Agenda
Village of Arlington Heights
Design Commission
Community Room, 3rd Floor

Arlington Heights Village Hall
33 S. Arlington Heights Road
Arlington Heights, IL 60005
October 14, 2014
6:30 PM

MINUTES OF
THE VILLAGE OF ARLINGTON HEIGHTS
DESIGN COMMISSION MEETING
HELD AT THE ARLINGTON HEIGHTS MUNICIPAL BUILDING
33 S. ARLINGTON HEIGHTS RD.
SEPTEMBER 23, 2014

DATE: August 26, 2014
TO: Chairman Eckhardt and Members of the Design Commission
FROM: Steve Hautzinger, Design Planner
RE: **DC Number: 14-058, Hickory/Kensington Area Design Guidelines**

A3.2

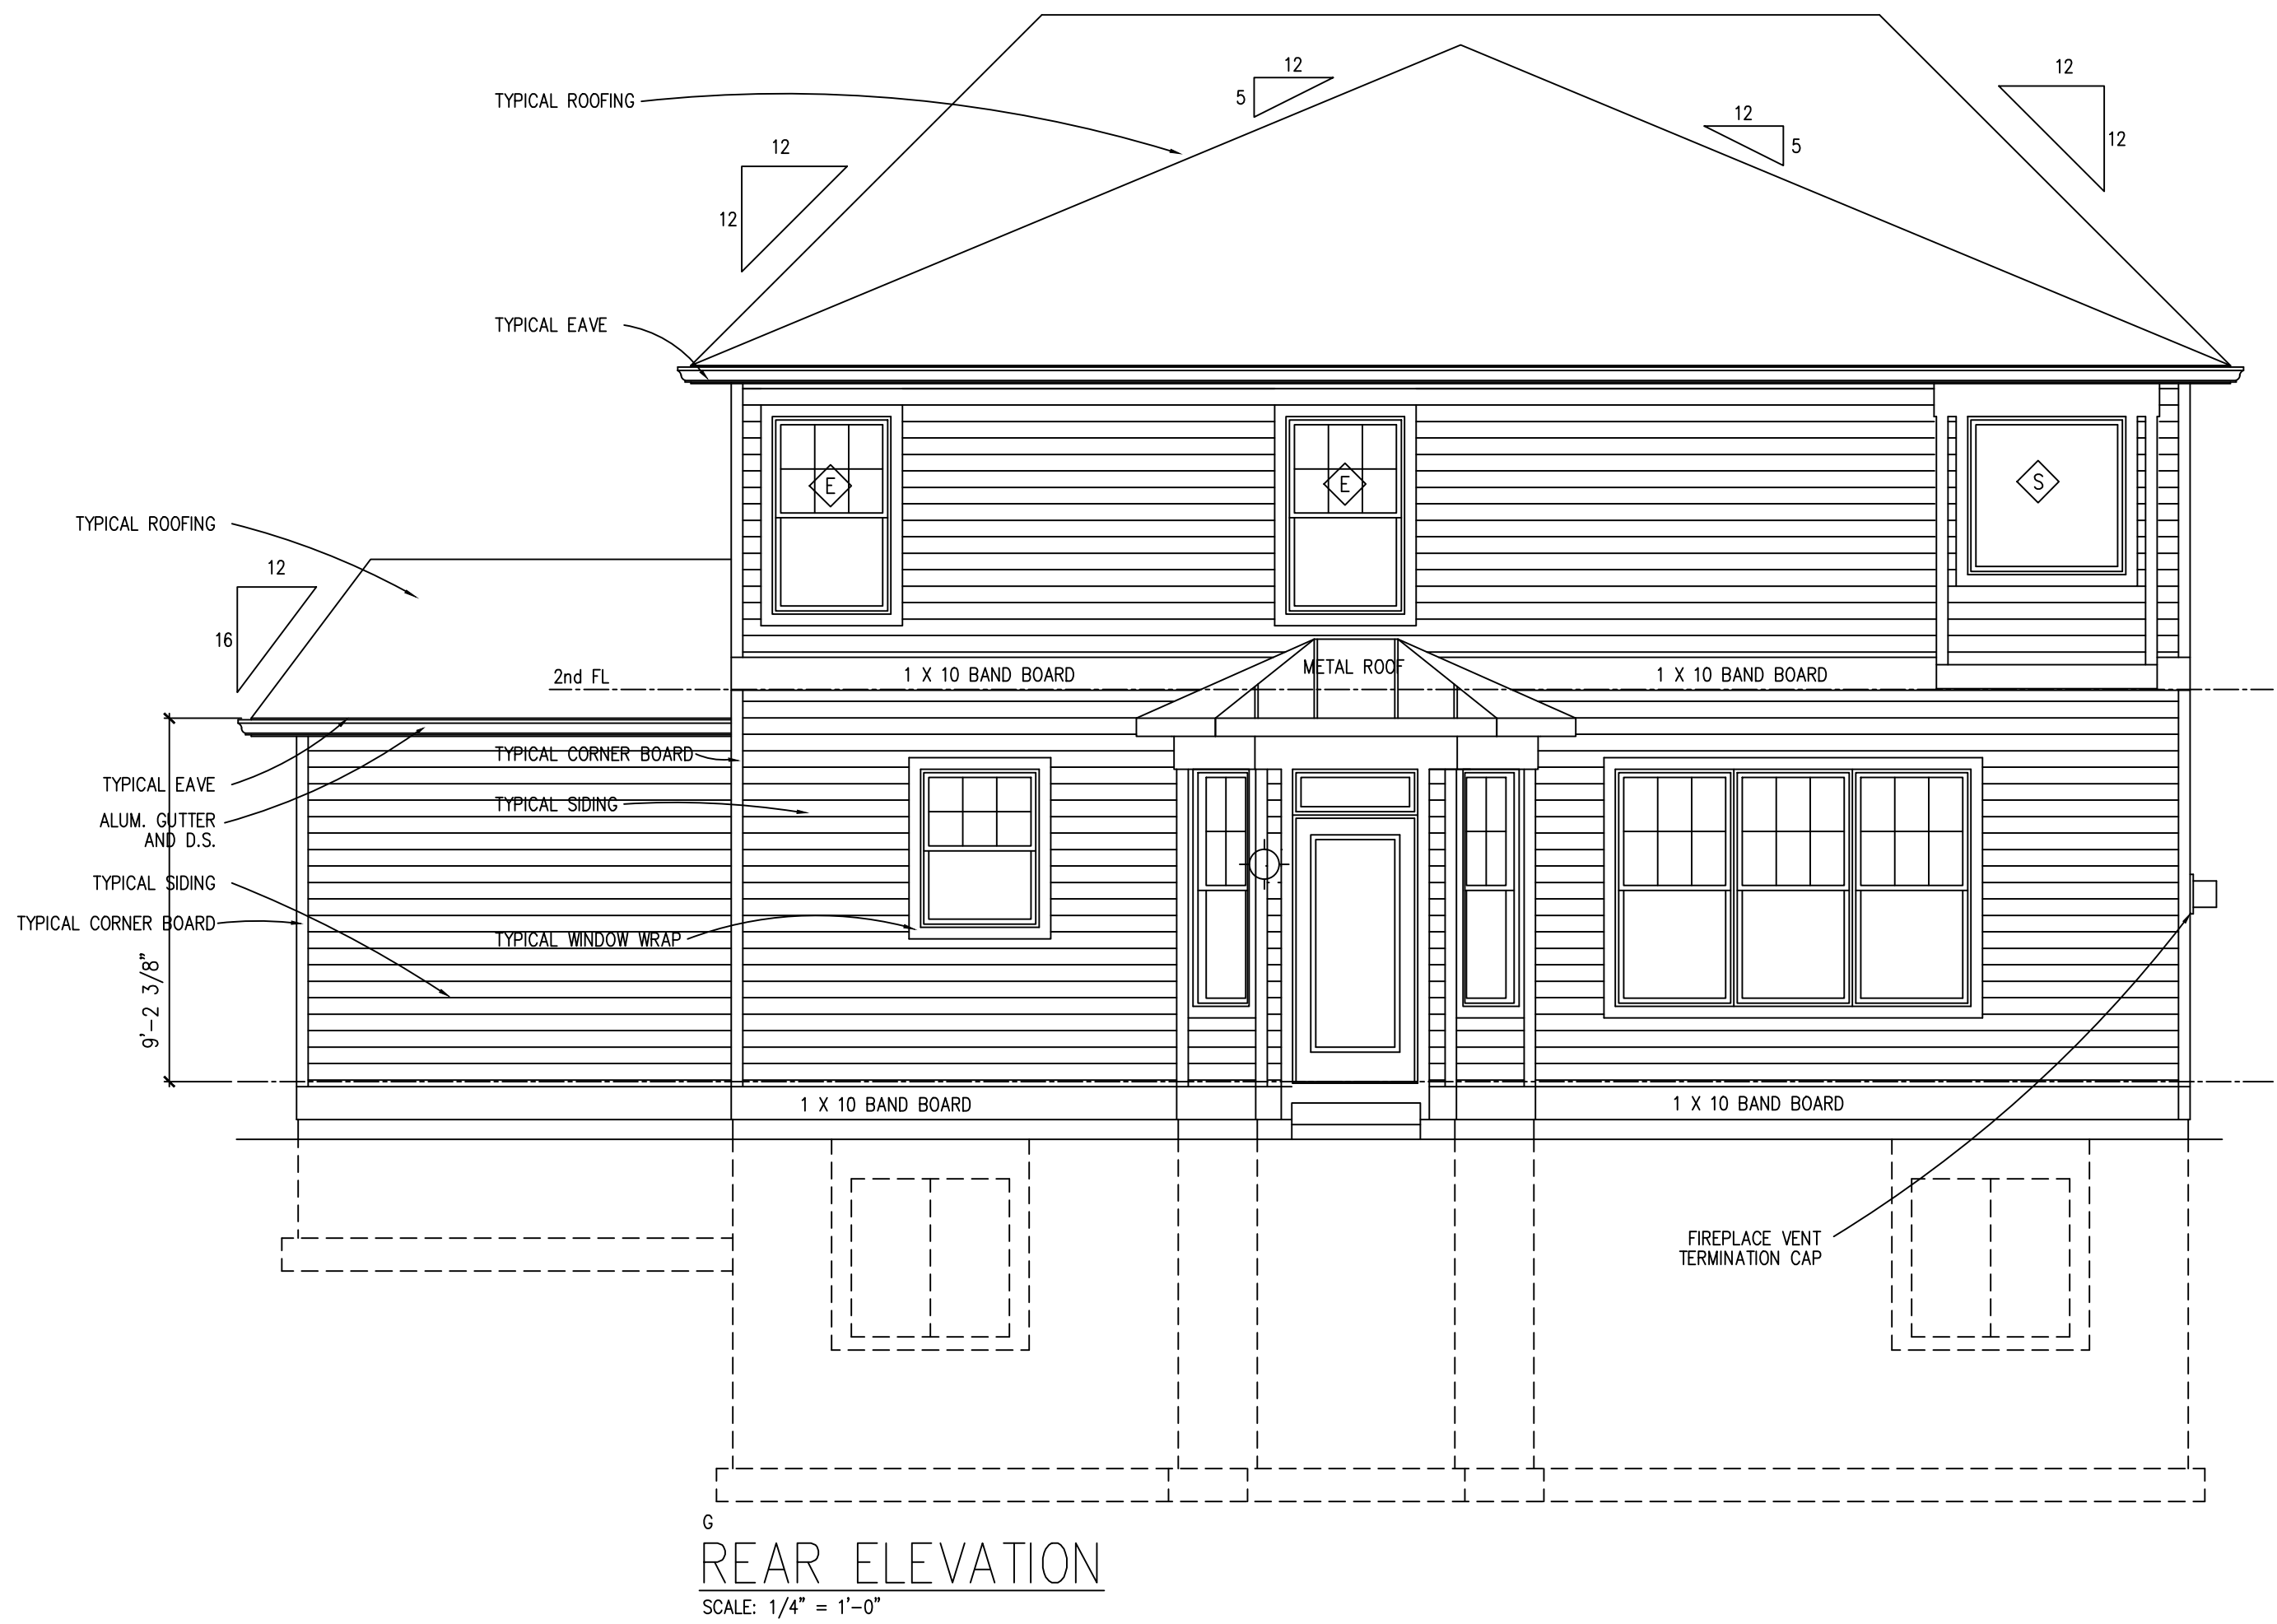
It is recommended the Design Commission approve the new single-family home to be located at 1805 N. Fernandez Avenue. This recommendation is subject to compliance with the architectural plans dated 5/18/14 and received on 5/13/14 and the following:

It is recommended that the Design Commission **approve** the proposed new single-family residence to be located at 1805 N. Fernandez Avenue. This recommendation is subject to compliance with the architectural plans dated 5/18/14 and received on 5/13/14, and the following:

JOB NO.	14051
DATE:	07-31-14
DRAWN BY:	MDS
SCALE:	AS NOTED
SHEET NO.	2
>FRONT ELEVATION >LEFT SIDE ELEV.	OF 8

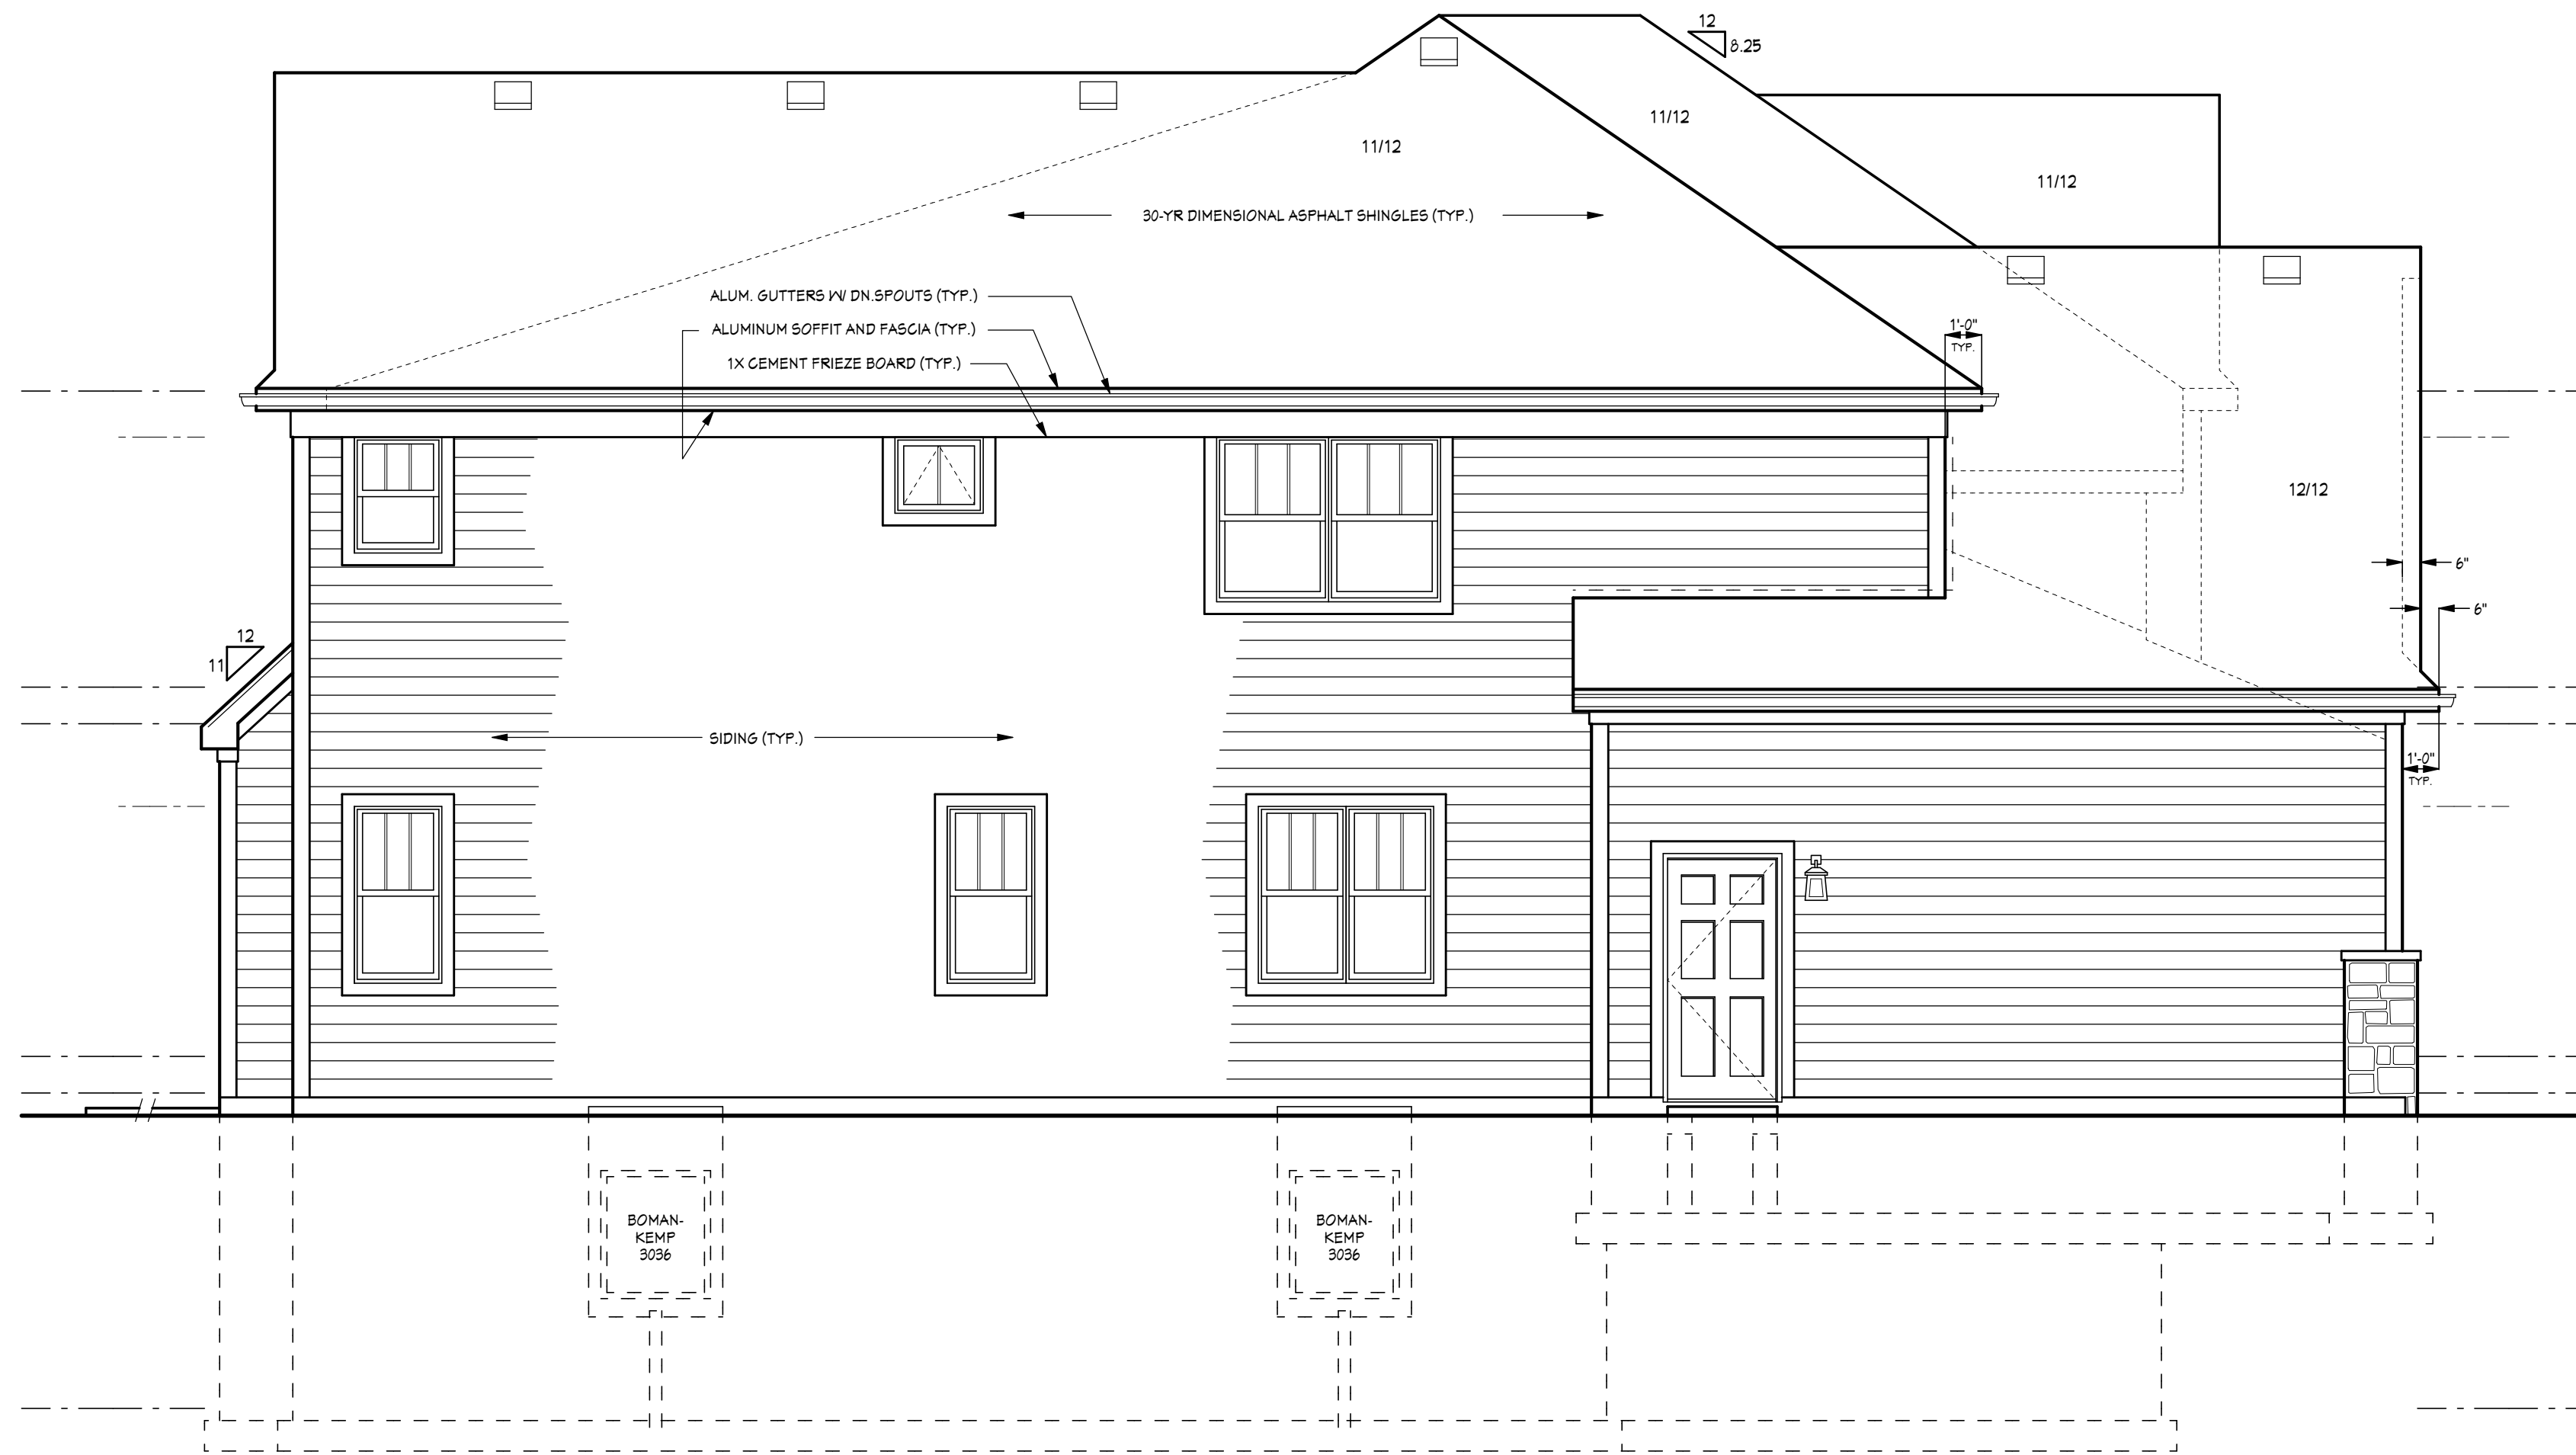
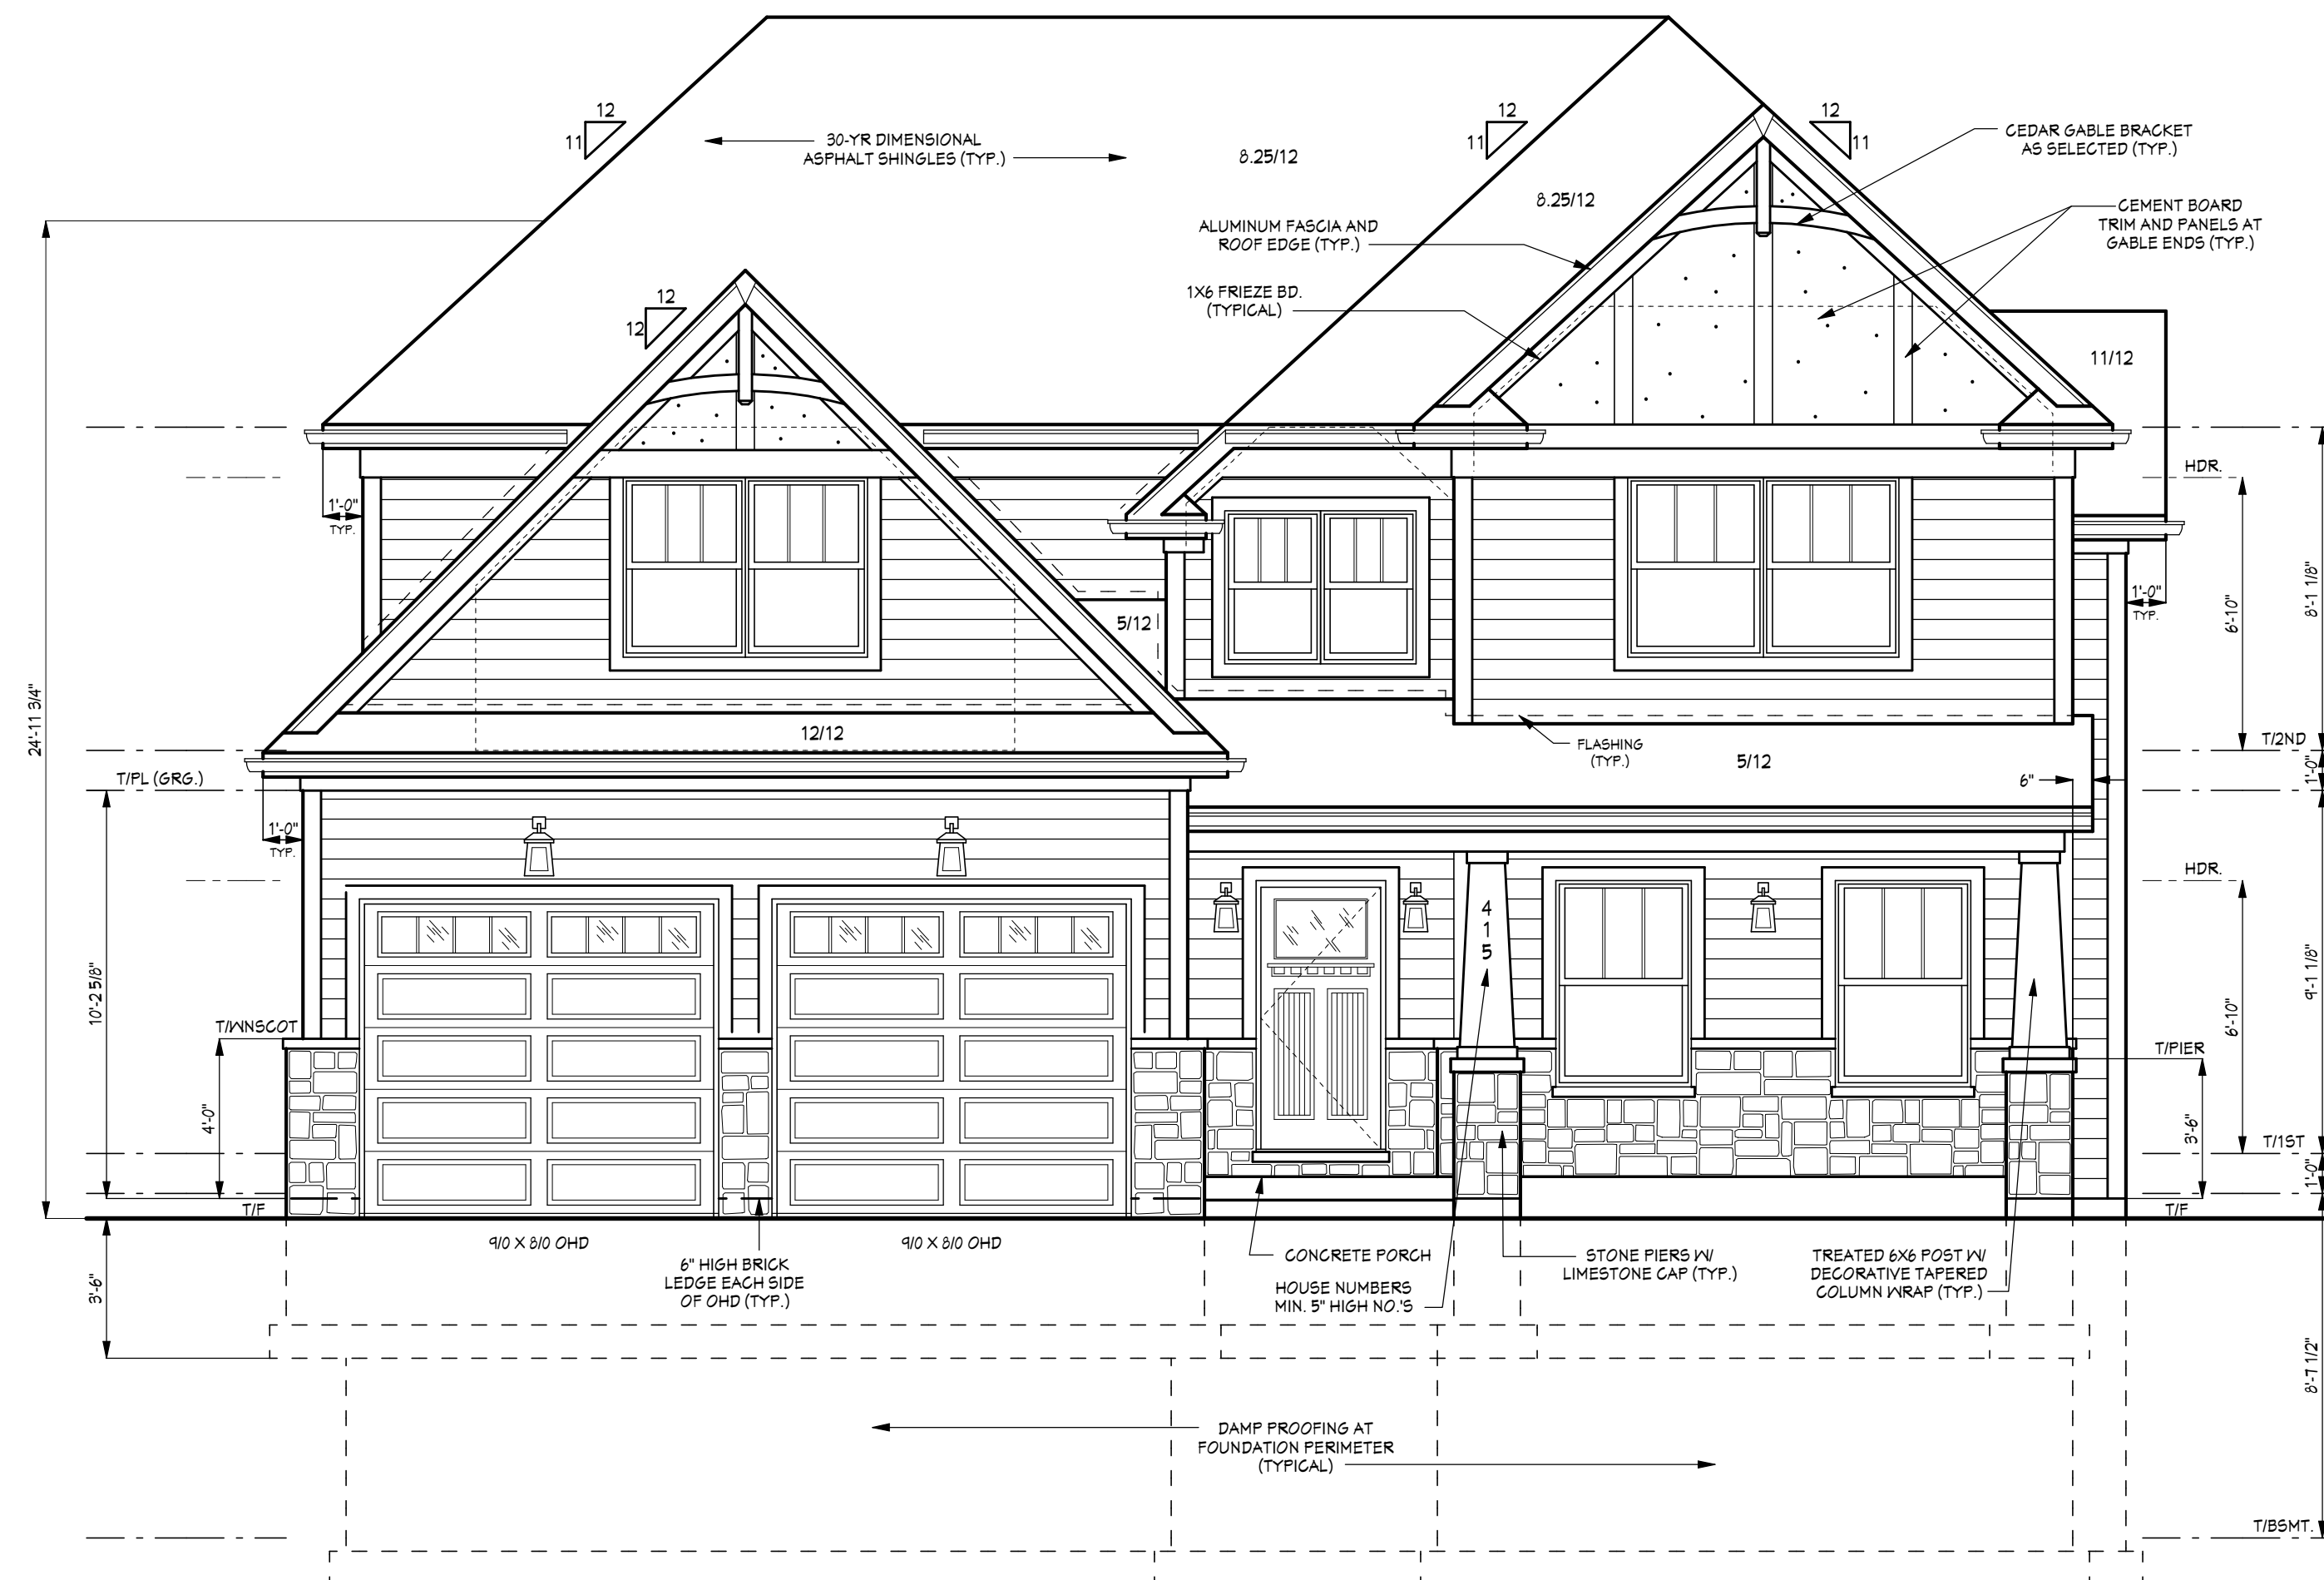
It is recommended that the Design Commission approve the proposed new single-family residence to be located at 1717 N. Ridge Avenue. This recommendation is subject to compliance with the architectural plans dated 8/01/14 and received on 9/04/14, and the following:

It is recommended that the Design Commission **approve** the proposed new single-family residence to be located at 1717 N. Ridge Avenue. This recommendation is subject to compliance with the architectural plans dated 8/01/14 and received on 9/04/14, and the following:
